SUBJECT: Forwards marked-up responses to NRC 810909 questions re  
 radiation protection open items. Two oversize drawings encl.  
 Aperture cards will be available in PDR.

Subject: Palo Verde Nuclear Generating Station  
(PVNGS) Units 1, 2, and 3  
Docket Nos. STN-50-528/529/530  
File: 81-056-026, G.1.10

Reference: Letter From R. L. Tedesco to E. E. Van Brunt, Jr.,  
Dated September 9, 1981; Subject: Comments on  
Responses to Radiation Protection Open Items.

Fig 13.1-6

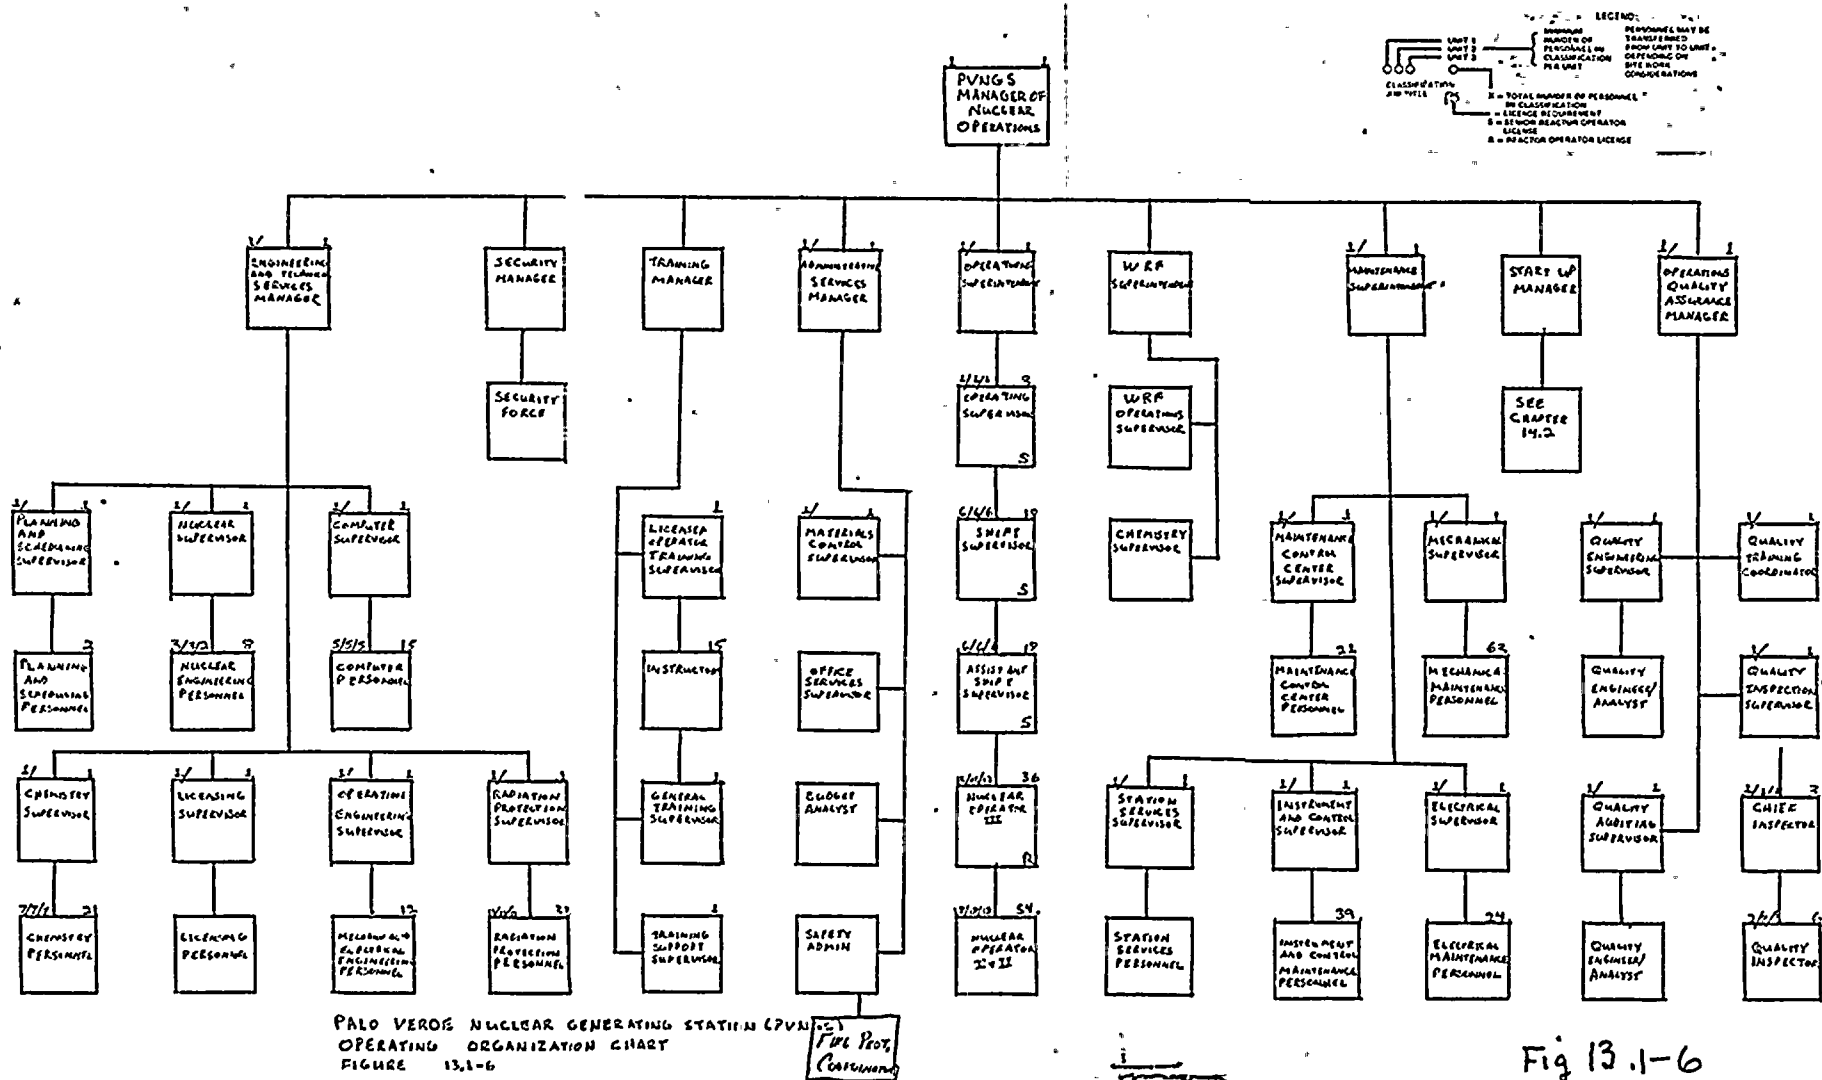
Figures 13.1-6 and 7 should be revised to show that radiation protection section is a separate organization.

See revised PVNGS FSAR figures 13.1-6 and 13.1-7, Attachment A.

DRAWING NO.	SHEET NO.	REV.	DCN NO.
13-J-ZCF-013		1	3

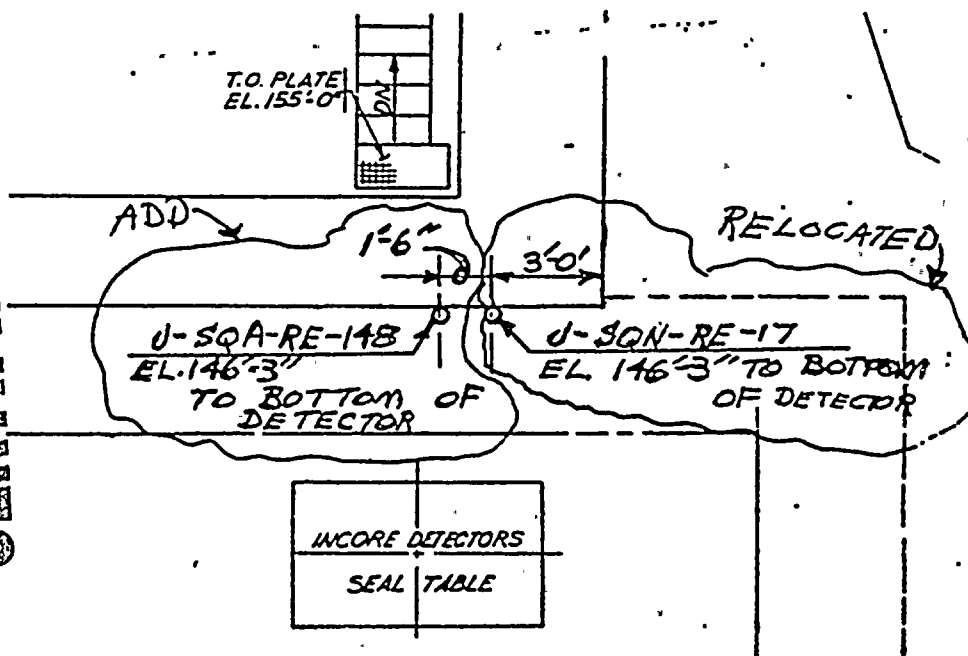
NUREG-0737, Item II.F.1.3 - The location of the containment high-range monitors should be specified.

REASON FOR CHANGE: ADDITIONAL RADIATION DETECTOR REQUIRED BY  
NU REG 1.97 & RELOCATED DETECTOR TO CORRECT

Locations of these monitors are provided on Attachments D and E.  
The containment area high range monitors are numbered RE148 and RE149.

ADD RE-148 & RELOCATE RE-17 AS SHOWN.
